**MANCHESTER-BOSTON REGIONAL AIRPORT
GREEN DRIVE CARGO FACILITY APRON AND ACCESS ROAD**

ADDENDUM NO. 1

DATE: March 17, 2022
TO: ALL BIDDERS
FROM: McFarland-Johnson, Inc.
53 Regional Drive
Concord, NH 03301
PROJECT: Manchester-Boston Regional Airport
Manchester, New Hampshire
Green Drive Cargo Facility Apron and Access Road

NOT TO SCALE
(INCIDENTAL TO ITEM M-300-5F)

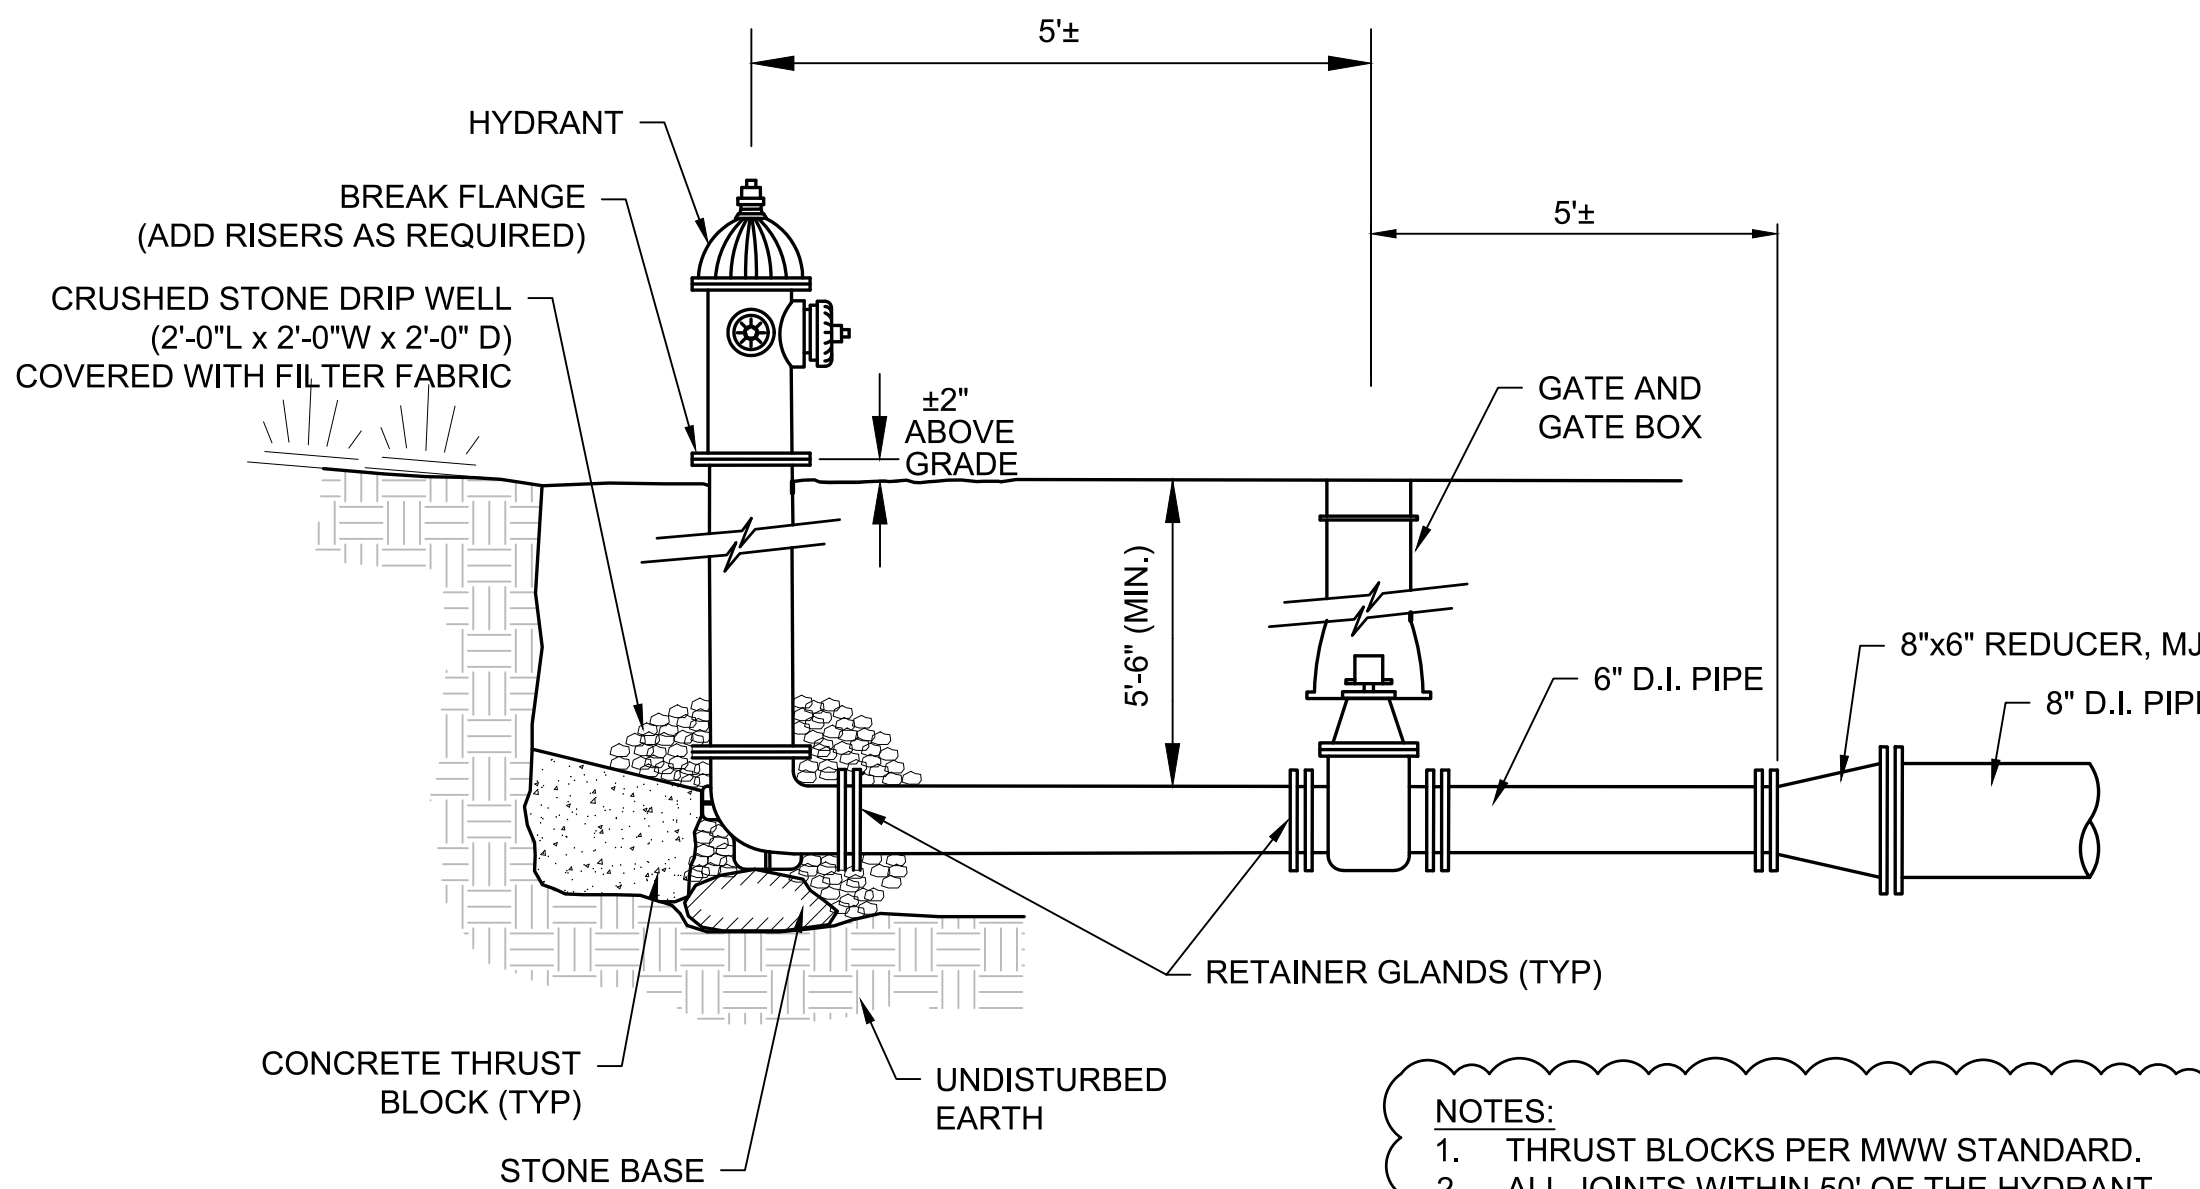
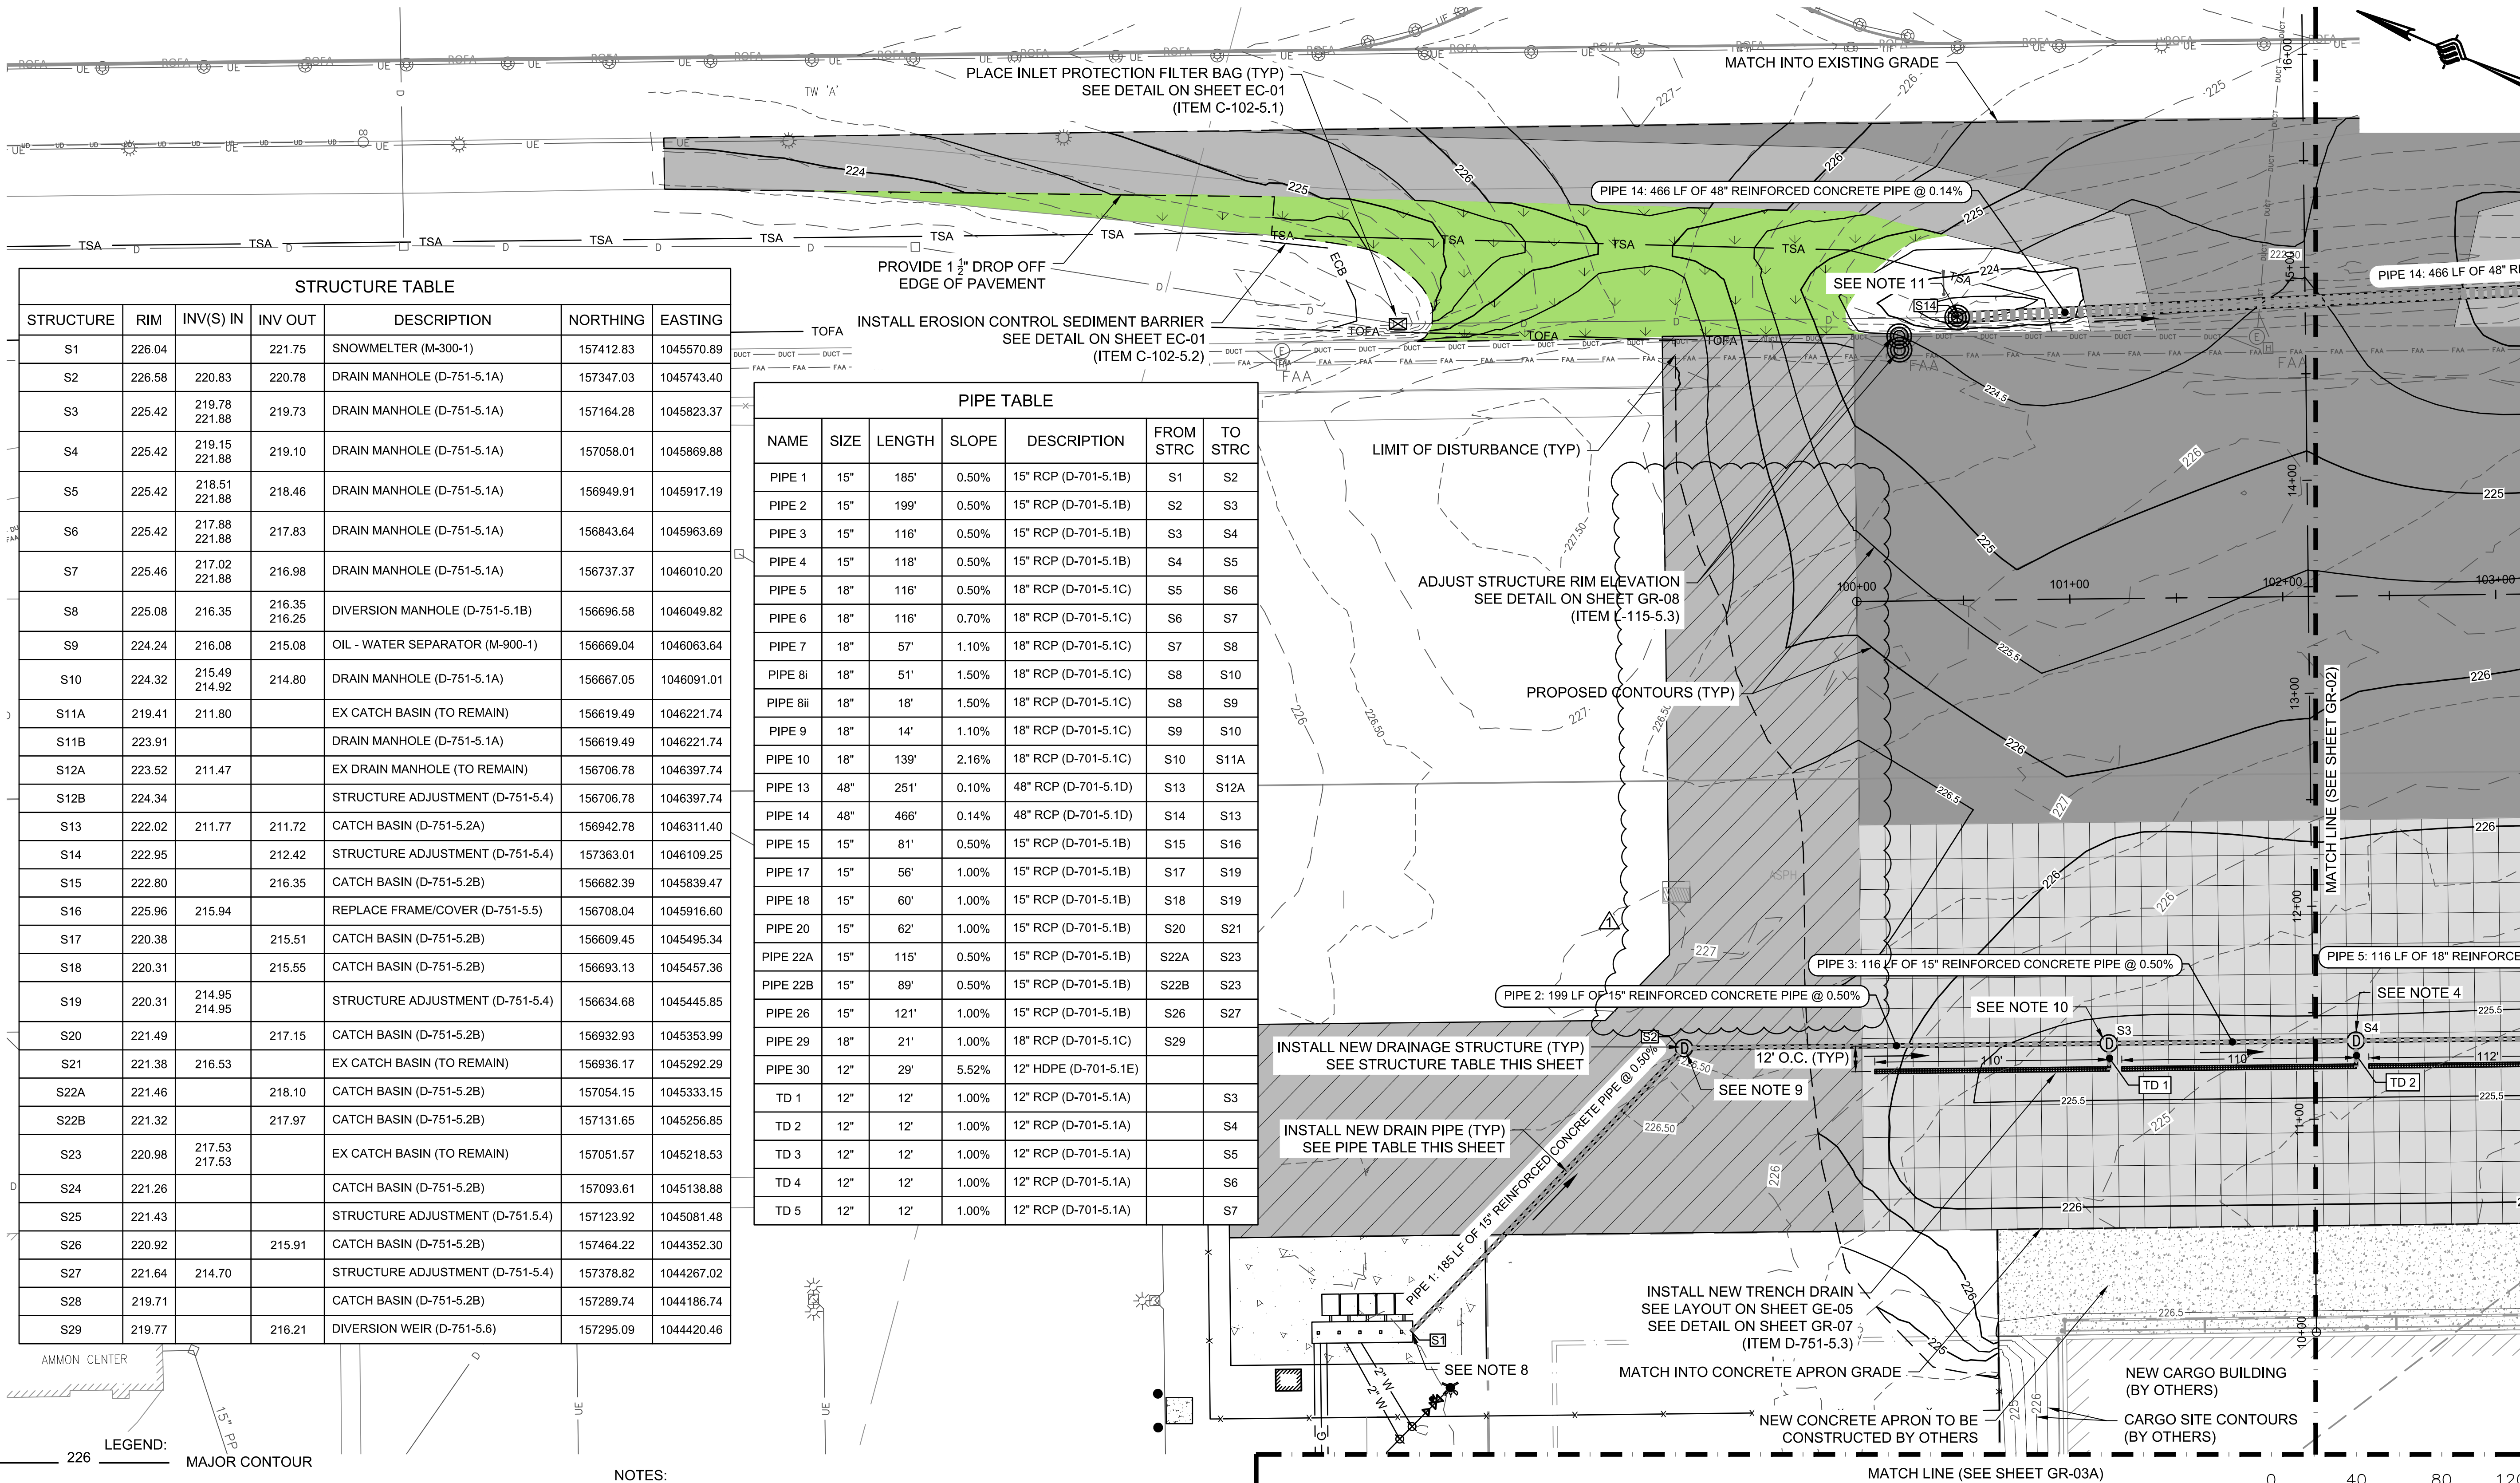
Section 300-2.8 Water Line and Fitting Materials, 3): **Replace 3) Material:** Remove Polyethylene Service Tubing and Replace with Copper Service Tubing

Section 300-2.8 Water Line and Fitting Materials: **Add 4) Material:** Add Polyethylene Wrap for Ductile Iron Pipe

Section 300-2.8 Water Line and Fitting Materials: **Add 14) Material:** Add Copper Meter Setters and Check Valves (No Lead Brass)
